CCO #SC01-001

Project: AS7.001.001 - Ogdensburg CSD CIP Phase 1
 1100 State Street
 Ogdensburg, New York 13669

**Change Order Authorization #SC01-001:
 CE #040 - Transportation Entrance Gate Changes**

SITE PLAN	
BUILDING	SHEET NUMBER
JC-14	2
	C-100

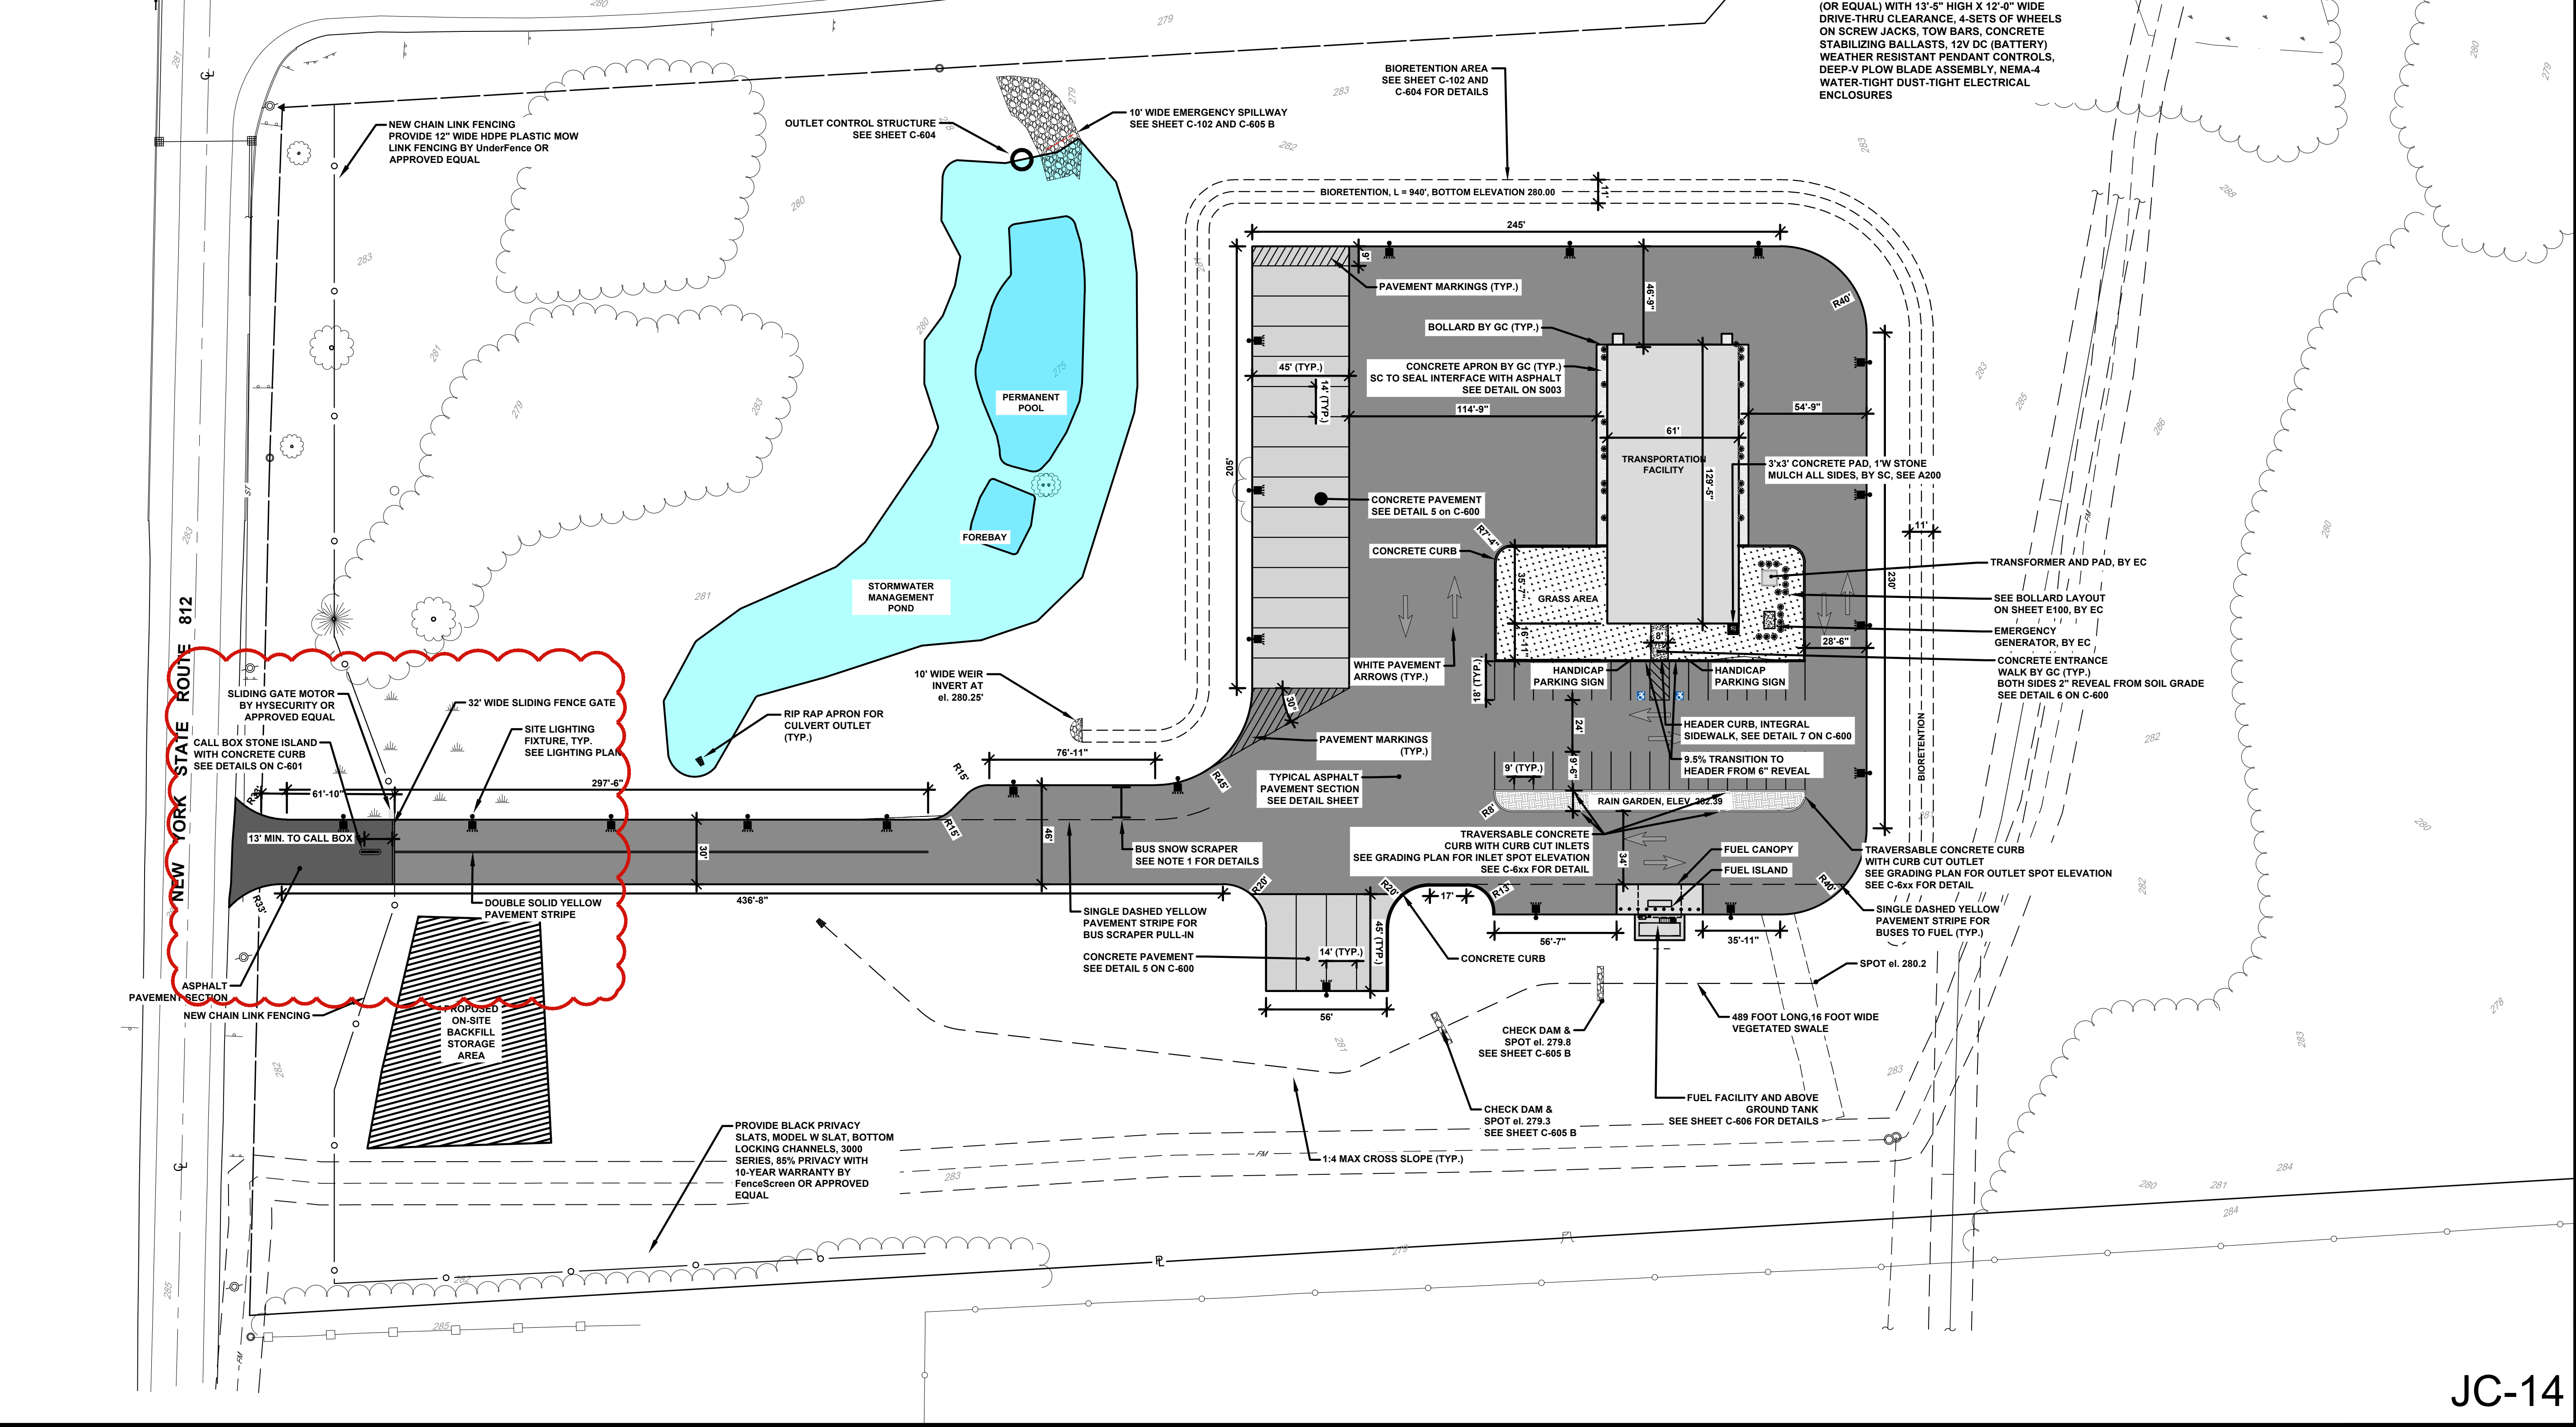
At the District's request, enhanced communication and security capabilities are being added at the entrance gate to the new Transportation Facility, per attached JC-14 drawings.	\$41,578.36
---	-------------

D.	Add for all labor, materials & equipment to provide enhanced security access control features to include exterior dual head camera & related pedestal, (2) Axis video intercoms w/ integrated card readers, fiber optic panel and access control panel for the drive entrance at the new Transportation Facility as per Contract Drawing(s) JC-14.
